Proposed Changes to IEEE Std 802.3, Sub-clauses 25.4.5, 25.4.5.1
and 25.4.7, to address the need for reduced Open Circuit
Inductance in Ethernet Magnetics

Revised August 25, 2011
August 2011

Figure 25-1—Type 2 system time constant test circuit

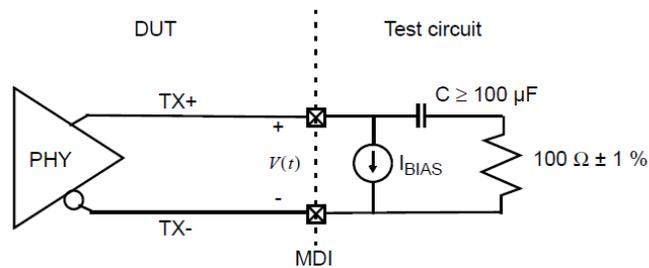
4. Change the Note for Figure 25-1 in section 25.4.5.1

NOTE-For transmitters in a Type 1 or Type 2 PSE or PD, I_{BIAS} is the current $I_{unb} / 2$ defined in Clause 33. For transmitters not in a Type 1 or Type 2 PSE or PD, I_{BIAS} is not required.
